190 Lexington Street Community Meeting Summary April 2, 2024

On April 2, 2024, Community Matters, with project applicant, Don Cusano, hosted a community meeting at the Holy Cross Armenian Catholic Church located on Lexington Street. In attendance were Father Ghazor Bedros, two members of the Holy Cross Church, and eight other residents of the neighborhood. Community Matters noticed a total of eleven properties (see attached abutters map).

Source: Shade Map App—www.shademap.app

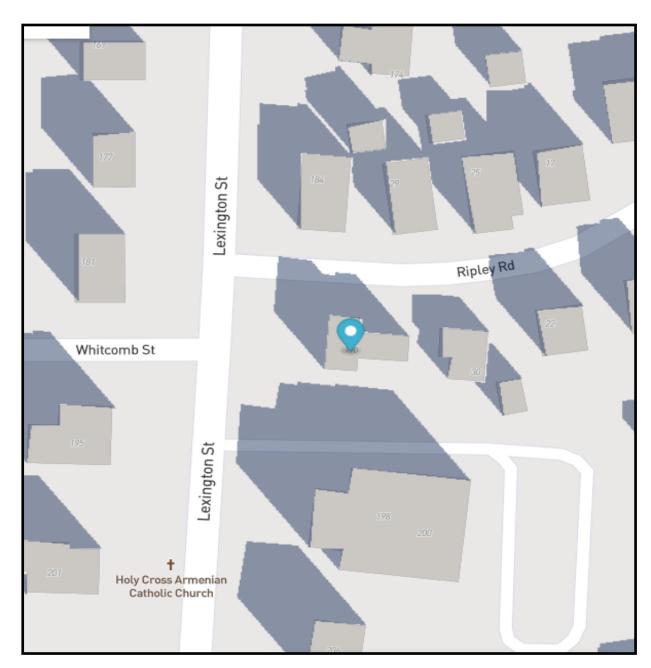
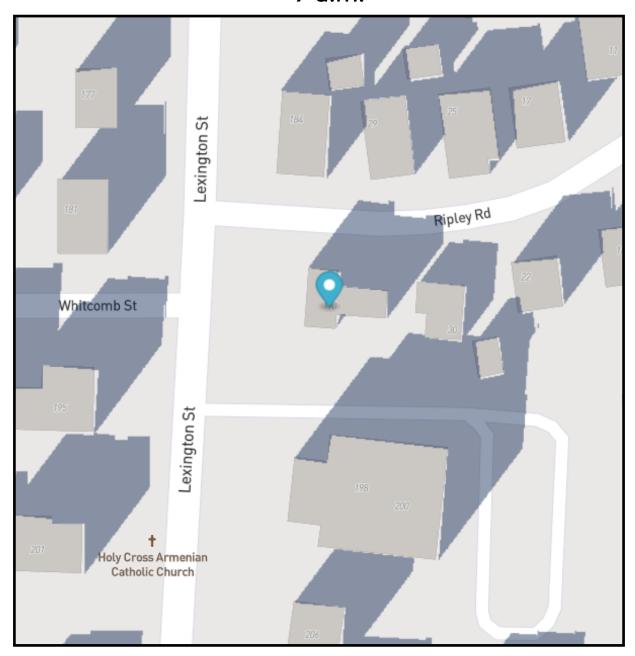
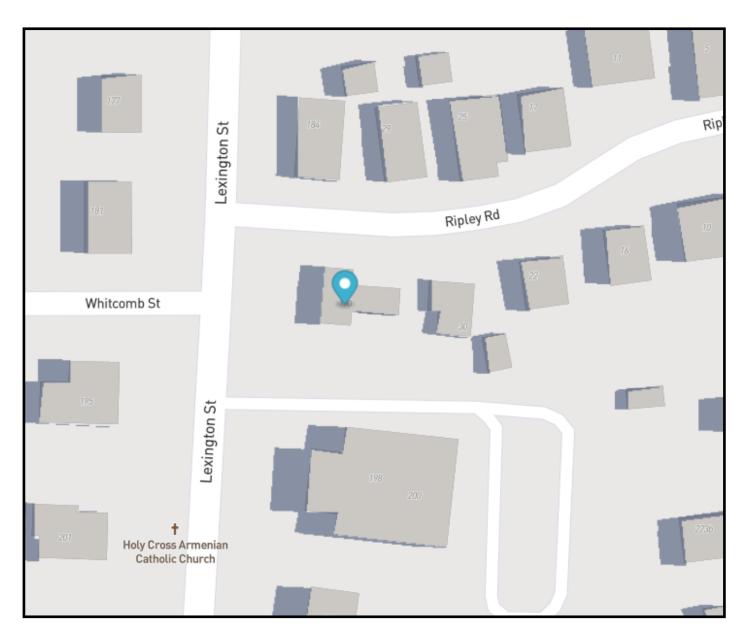
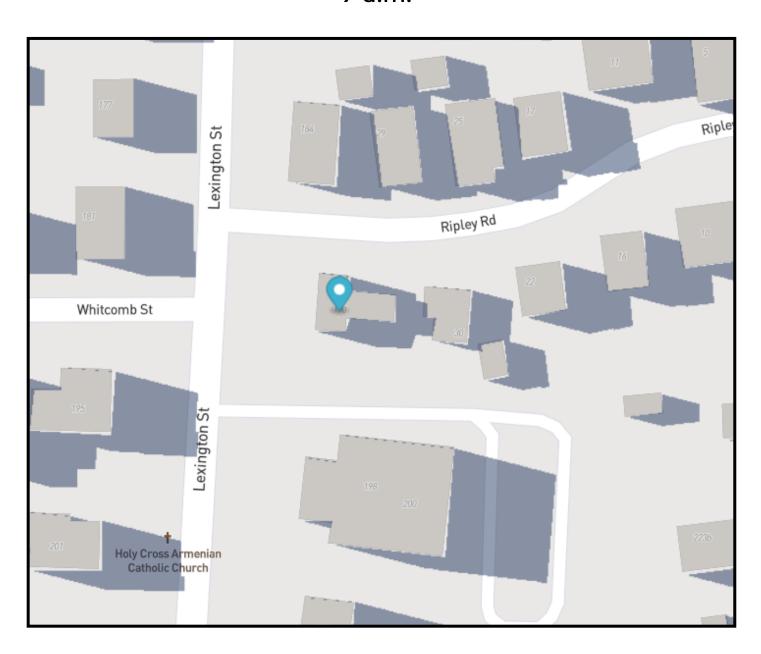
Neighborhood - Will shade be an issue on surrounding properties?
 Applicant - Community Matters and Mr. Cusano shared the shade and shadow exhibits prepare for the meeting showing no or minimal casting on adjacent properties based on existing conditions and the fact that the proposed development would have similar castings of shade.
